Site Address: 181 Toronto St S	Date: April 11, 2024	LSRCA File #: SD-220826-071322	Municipal Ref #: SUB 2022-02
Application Type: Subdivision	APID: 220826	Submission #: SECOND	Municipality: Uxbridge

Documents Reviewed (11-APRIL-2024):

- REPORT: Counterpoint, “Stormwater Management and Functional Servicing Report in support of Site Plan application”, dated November 24, 2023
- ENGINEERING DRAWING SET: engineer stamped dated Nov. 24/23
- COMMENT MATRIX: dated 2024.03.07

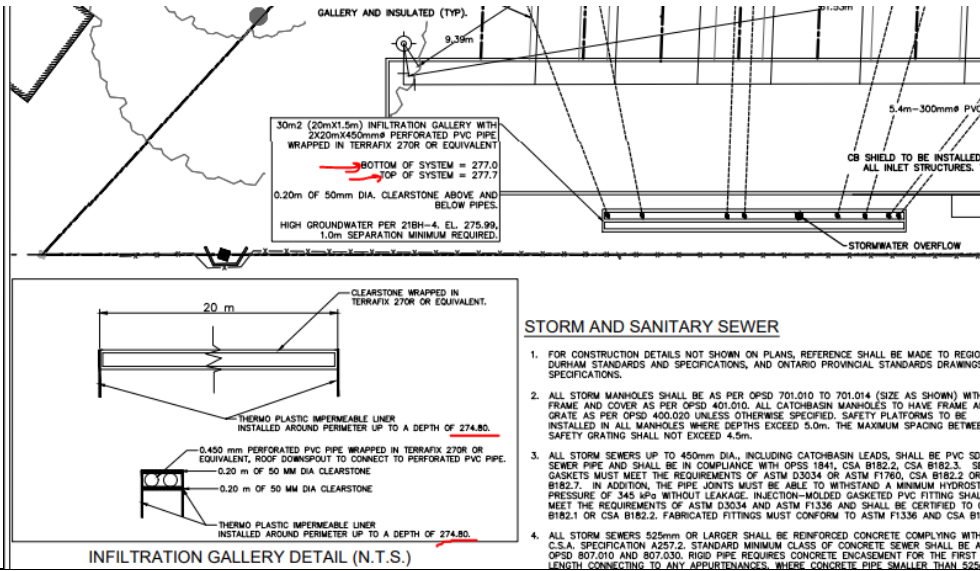
E3.	SWM Report	Section 5.0	Page 5	<p>Water Quantity Control using Infiltration Measures (for the Rooftops): Please note that if a credit for infiltration is desired (for the rooftops) to address the water quantity criteria, it will be necessary to follow the requirements as laid out in Appendix B of the April 2022 LSRCA SWM Technical Guidelines.</p> <p>If the intent is not to obtain an infiltration credit to address the water quantity control criteria, please state such and indicate how and where it will be accounted for.</p> <p>Please keep in mind LSRCA SWM guideline April 2022, section 3.2.1 states “Infiltration measures may be considered for peak flow control credits, subject to the conditions as described in Appendix B.” guidelines.</p> <p>Please provide all supporting information, documentation, findings, etc. to support the constraints / criteria outlined in Appendix B.</p>	Infiltration and supporting documents updated to meet LSRCA criteria.	<p>Partially Addressed. LSRCA staff is under the impression the SWM report no longer accounts for the volume provided within the infiltration chamber towards the required storage to address the water quantity control criteria. Please clarify.</p> <p>If it is counted towards achieving water quantity than provide a detailed matrix, within the text of the report, outlining how each item is addressed in Appendix B.</p>	The chamber (Stormtech Chamber: SC-310) is not used for quantity control. It is only used to address water balance and volume control requirements.
